## 40/50/60 EFI FourStroke 4 Cylinder Ignition Coil Testing Specifications

Models Covered	Serial Number or Year
40/50/60 EFI FourStroke 4 cylinder engines	1C050252 and above

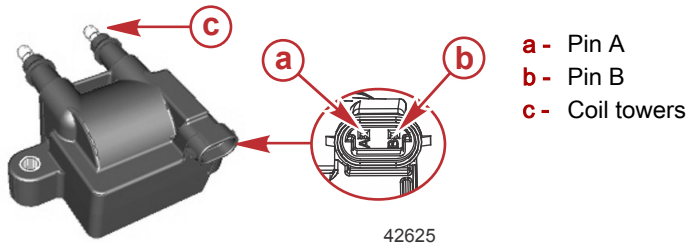
Mercury Marine has found an error in the service manual 90-8M0105570 for the 40/50/60 FourStroke 4 cylinder engines. The ignition coil testing specifications section has the incorrect resistance values published.

Refer to the table on information for revised ignition coil testing specifications.

Ignition Coil Resistance Test	
Between coil towers	7200–8800 Ω
Between pin A and B	0.3–0.5 Ω
